Access Compliance Report

(Curb Ramps)

Intersection ID: 26286	Main Street: BEVINGTON_BROOK_LN	Cross Street: BEVINGTON_WOODS_LN	Location: E
ADA ID: 14F309195B8D	Ramp Type: PerpDiag	Initial Pass/Fail: Fail	Overall Compliance: No
Severity Score: 21.25			
Codes/Mitigation Info/Possible Solution		Field Measurements/Component Compliance

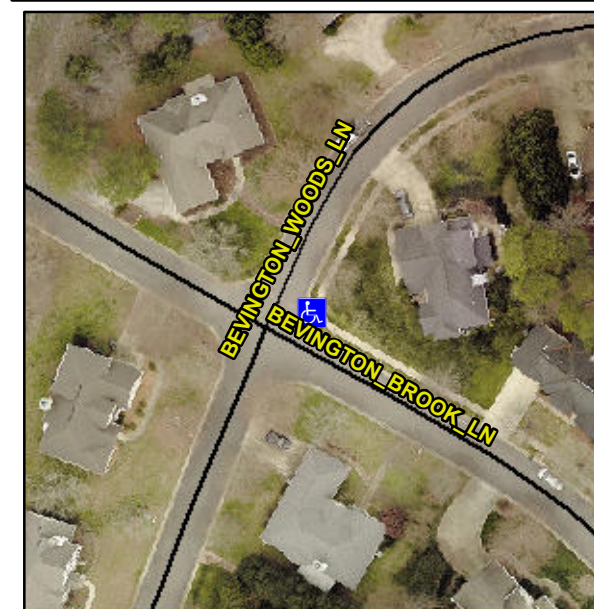
Not Found, R304.5.1, R304.5.3

Compliance	Description	Data	Compliance	Description	Data
N/A	Ramp Length (in)	92.0	Yes	Ramp Slope (%)	6.9
No	Ramp Width (in)	47.0	No	Ramp XSlope (%)	5.2
N/A	Flare Type LT	N/A	N/A	Flare Type RT	N/A
N/A	Flare Slope LT (%)	N/A	N/A	Flare Slope RT (%)	N/A
N/A	Flare Traversable LT?	N/A	N/A	Flare Traversable RT?	N/A
N/A	Landing Length (in)	N/A	N/A	DWS Provided?	N/A
N/A	Landing Width (in)	N/A	N/A	DWS Contrast?	N/A
N/A	Landing Slope (%)	N/A	N/A	DWS Length (in)	N/A
N/A	Landing X Slope (%)	N/A	N/A	DWS Full Width?	N/A
N/A	Landing Curb? (Y/N)	N/A	N/A	DWS Offset (in)	N/A
N/A	Shared Landing?	N/A			
N/A	Gutter Ponding?	N/A	N/A	Gutter Slope (%)	N/A
N/A	Gutter Lip Ht (in)	N/A	N/A	Gutter X Slope (%)	N/A
N/A	Painted X Walk1?	No	N/A	Painted X Walk2?	No
	X Walk 1 Direction	To NW		X Walk 2 Direction	To SW
N/A	X Walk 1 Width (in)	N/A	N/A	X Walk 2 Width (in)	N/A
	X Walk 1 Slope (%)	2.6		X Walk 2 Slope (%)	3.3
	X Walk 1 X Slope (%)	1.4		X Walk 2 X Slope (%)	1.0

Remove & Replace Curb Ramp With Two New Directional Ramps or Equivalent.
